Access Compliance Report

Public Rights-of-Way

(Curb Ramps)

Intersection ID: 29515	Main Street: ROSS_MOORE_AV	Cross Street: SILABERT_AV	Location: NE
ADA ID: BB7F61309530	Ramp Type: PerpDiag	Initial Pass/Fail: Fail	Overall Compliance: No
Severity Score: 21.25			
Codes/Mitigation Info/Possible Solution		Field Measurements/Component Compliance

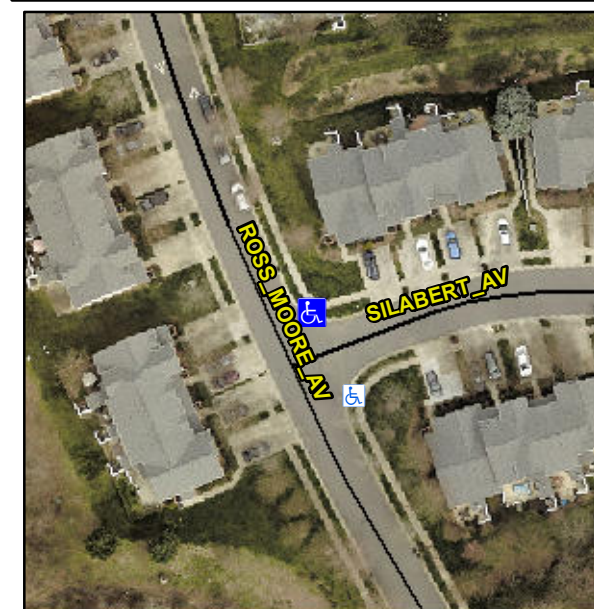
Surveyor Notes:

N/A

R304.5.1, R304.5.3

Compliance	Description	Data	Compliance	Description	Data
N/A	Ramp Length (in)	48.0	Yes	Ramp Slope (%)	5.3
No	Ramp Width (in)	41.5	No	Ramp XSlope (%)	6.2
N/A	Flare Type LT	N/A	N/A	Flare Type RT	N/A
N/A	Flare Slope LT (%)	N/A	N/A	Flare Slope RT (%)	N/A
N/A	Flare Traversable LT?	N/A	N/A	Flare Traversable RT?	N/A
N/A	Landing Length (in)	N/A	N/A	DWS Provided?	N/A
N/A	Landing Width (in)	N/A	N/A	DWS Contrast?	N/A
N/A	Landing Slope (%)	N/A	N/A	DWS Length (in)	N/A
N/A	Landing X Slope (%)	N/A	N/A	DWS Full Width?	N/A
N/A	Landing Curb? (Y/N)	N/A	N/A	DWS Offset (in)	N/A
N/A	Shared Landing?	N/A			
N/A	Gutter Ponding?	N/A	N/A	Gutter Slope (%)	N/A
N/A	Gutter Lip Ht (in)	N/A	N/A	Gutter X Slope (%)	N/A
N/A	Painted X Walk1?	No	N/A	Painted X Walk2?	No
	X Walk 1 Direction	To W		X Walk 2 Direction	To S
N/A	X Walk 1 Width (in)	N/A	N/A	X Walk 2 Width (in)	N/A
	X Walk 1 Slope (%)	2.4		X Walk 2 Slope (%)	1.4
	X Walk 1 X Slope (%)	1.9		X Walk 2 X Slope (%)	1.9

Remove & Replace Curb Ramp With Two New Directional Ramps or Equivalent.
